# NSBA Steel Bridge Forum

## Cost Effective and Efficient Detailing for Fabrication of Steel Girders

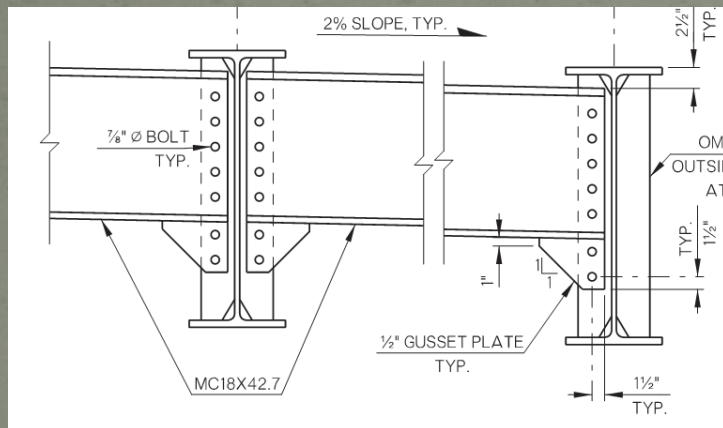
- When possible avoid expensive sections such as W40s and MCs
- Depending on market conditions and schedule, fabricating a plate girder can be less expensive than W40s. In multiple cases we have seen savings of as much as 10% on the total steel package.

THE CONTRACTOR MAY PROPOSE PLATE GIRDERS USING EQUIVALENT SECTION PROPERTIES IN LIEU OF THE ROLLED BEAM SHAPE SHOWN AT NO ADDITIONAL COST TO THE DEPARTMENT. PROVIDE  $\frac{5}{16}$ " MINIMUM FILLET WELDS BETWEEN WEB AND FLANGES. NON-DESTRUCTIVE TESTING WILL BE REQUIRED AS APPROPRIATE.

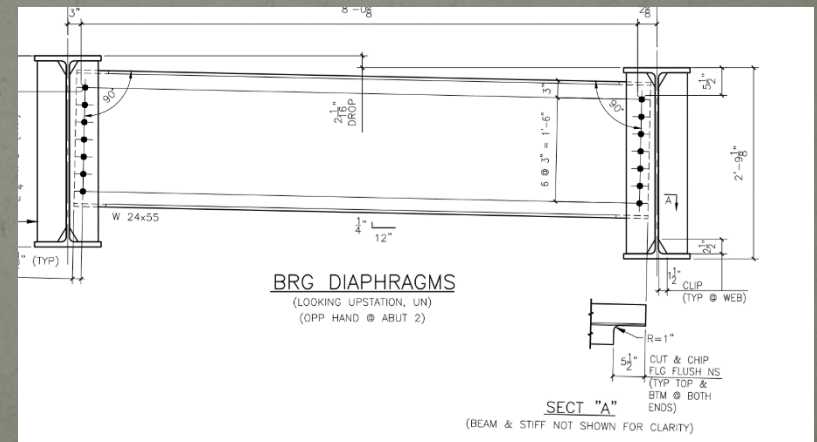
- MC diaphragms can cost up to 60% more than bent plate diaphragms or rolled beams. Especially if tab plates are welded to the MCs.

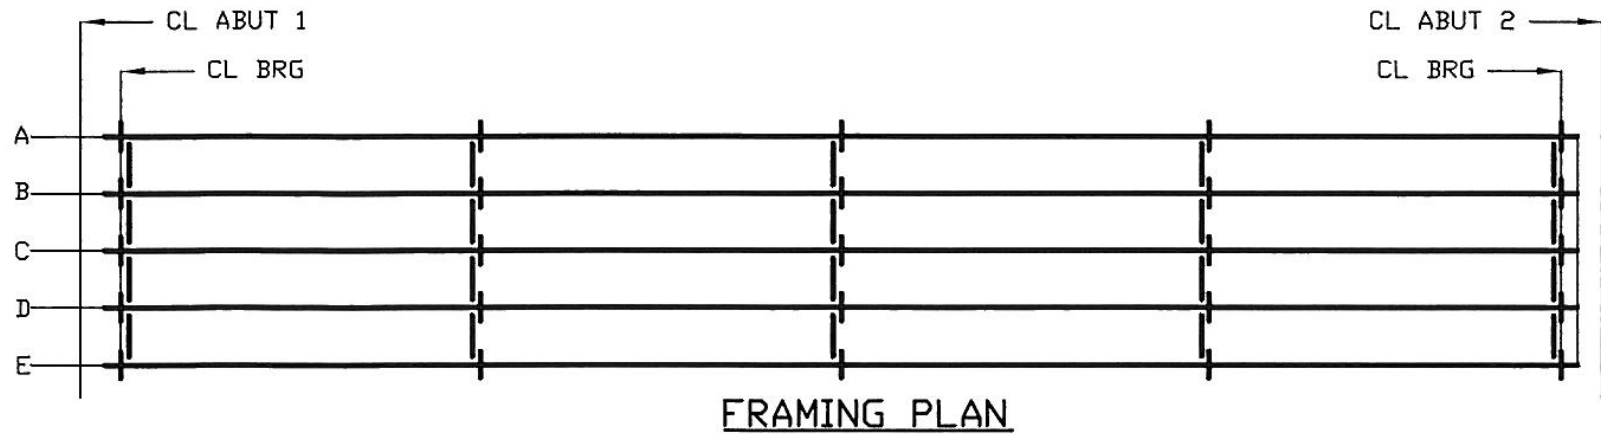
- What is slab splicing and why does it matter to you?
- Splicing can dictate your delivery schedule.
- Slab splicing is up to 34% more efficient than splicing single flanges.

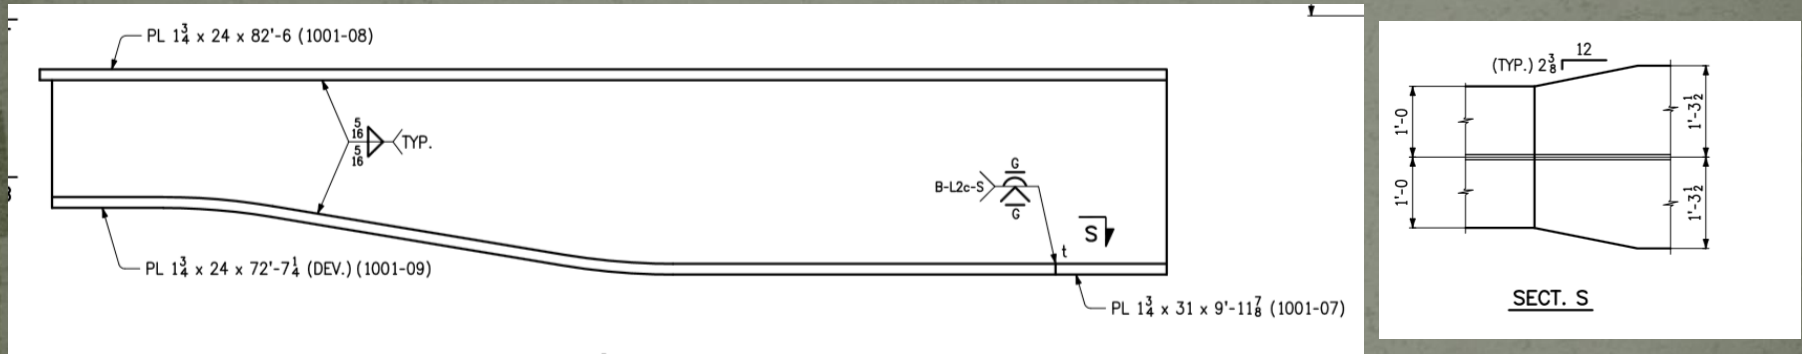
- Limit flange width transitions to field splice locations.

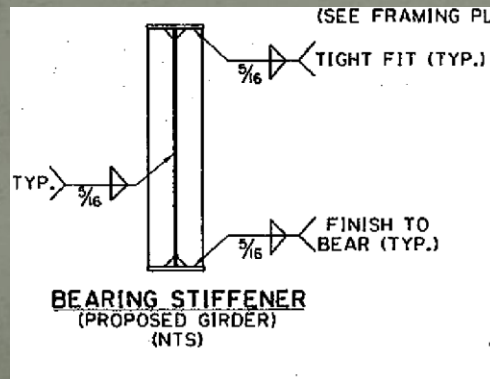
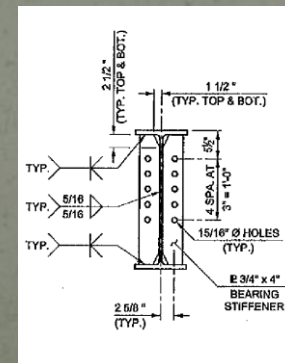
- Finish to bear in lieu of full pen welded stiffeners can save 10-15% on stiffener fitting/welding cost.

**NOTE FULL LENGTH WELDS**

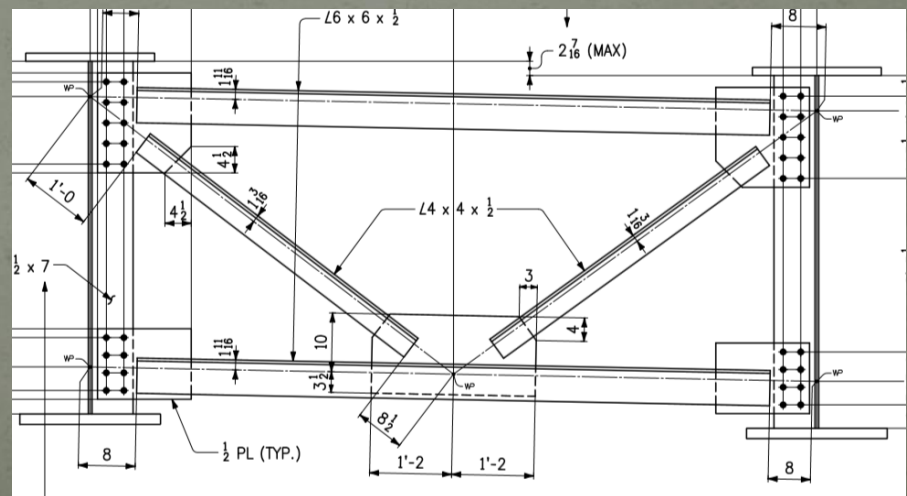
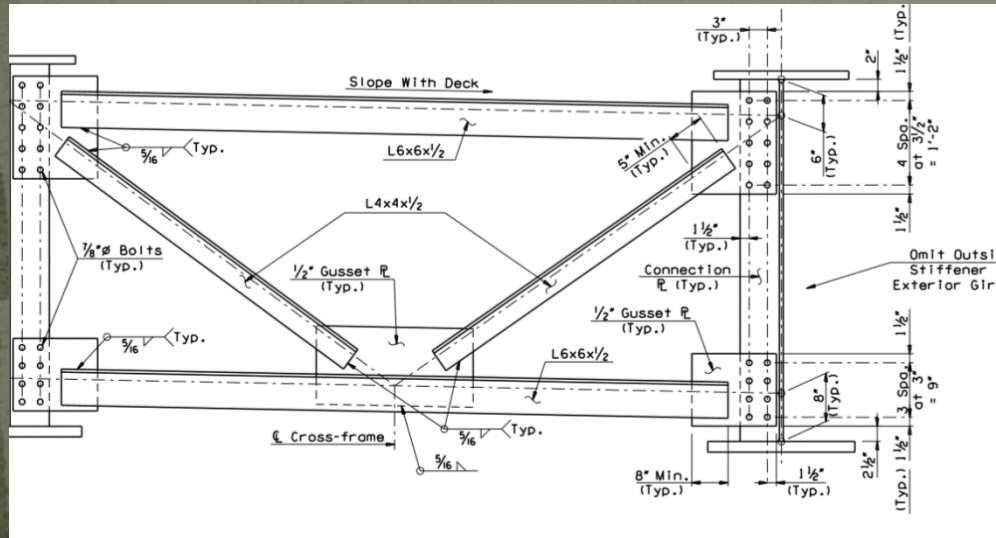
- Avoid the use of back to back angles.
- K-frames with all welding on one side eliminates the need to flip crossframes in the shop.
- Please specify minimum weld lap sizes. This allows the fabricator to create non-rectangular gussets and reduce the amount of welding required.
- Use larger bolt diameters to reduce the number of bolt holes in crossframes. 1" dia. A325 bolts are readily available.
